UN Regulation No. 73 (Lateral Protection Devices)

Proposal for the 02 Series of Amendments to UN Regulation No. 73 (Lateral Protection Devices)

Submitted by the expert from Japan *

Figure 1

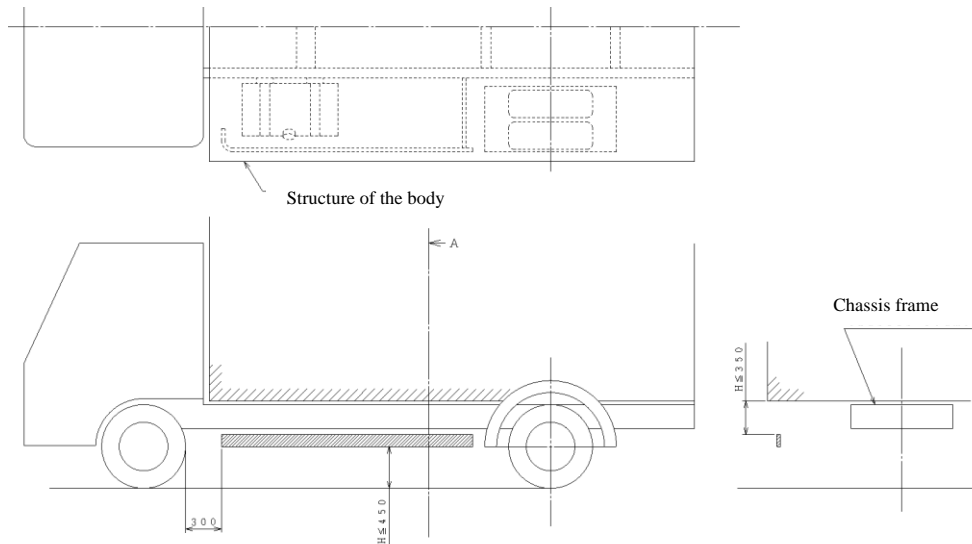
"12.9. The upper edge of LPD shall not be more than 350 mm below that part of the structure of the vehicle, cut or contacted by a vertical plane tangential to the outer surface of the tyres, excluding any bulging close to the ground (see **Figure 1 below**), except in the following cases:

Figure 2

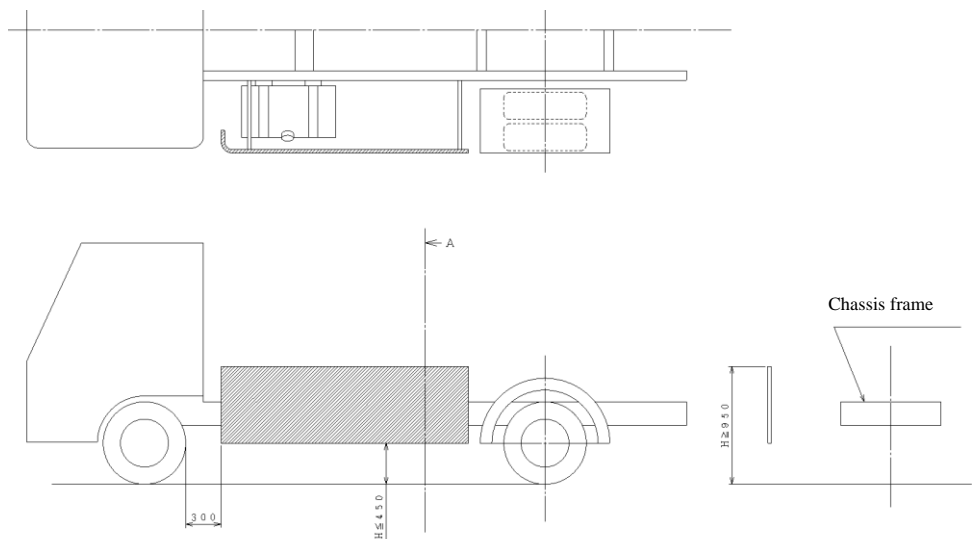
12.9.1. Where the plane in paragraph 12.9. does not cut the structure of the vehicle **or cuts the structure of the vehicle at a level more than 1.3 m above the ground, then the upper edge shall not be less than, then the upper edge shall be level with the surface of the load-carrying platform, or 950 mm above the ground (see Figure 2 below);**

Figure 3

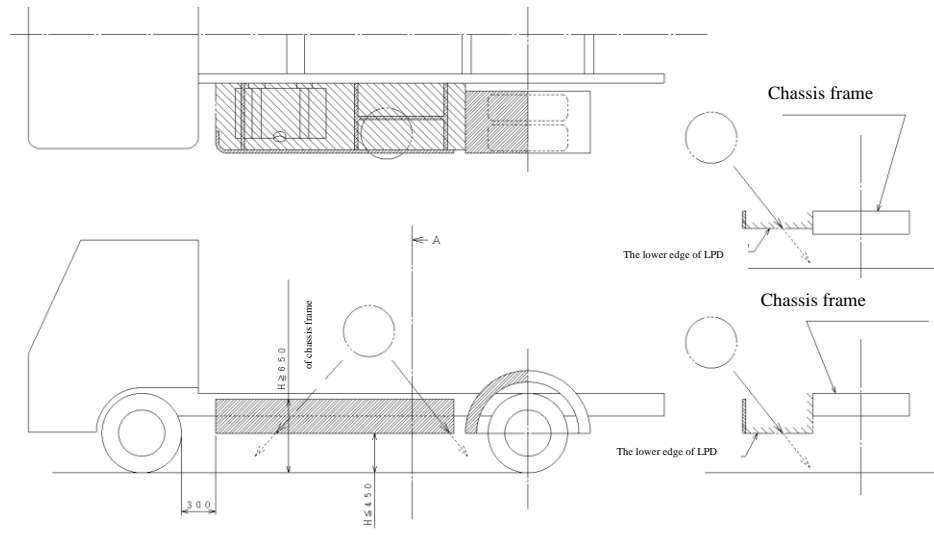
The upper edge of LPD is [650] mm above the ground, be level with the surface of the chassis frame, whichever is less, and the structure is

designed to prevent cyclists from falling under the vehicle fly over the LPD (see Figure 2 below).

The fall prevention shall be demonstrated by the structure not allowing the [450] mm sphere to fall to the ground from the area enclosed by the LPD, chassis frame, and fender.

Other methods may be adopted to comply with this requirement if a manufacturer so requests. The sufficiency of the fall prevention method shall be established to the satisfaction of the Technical Service.
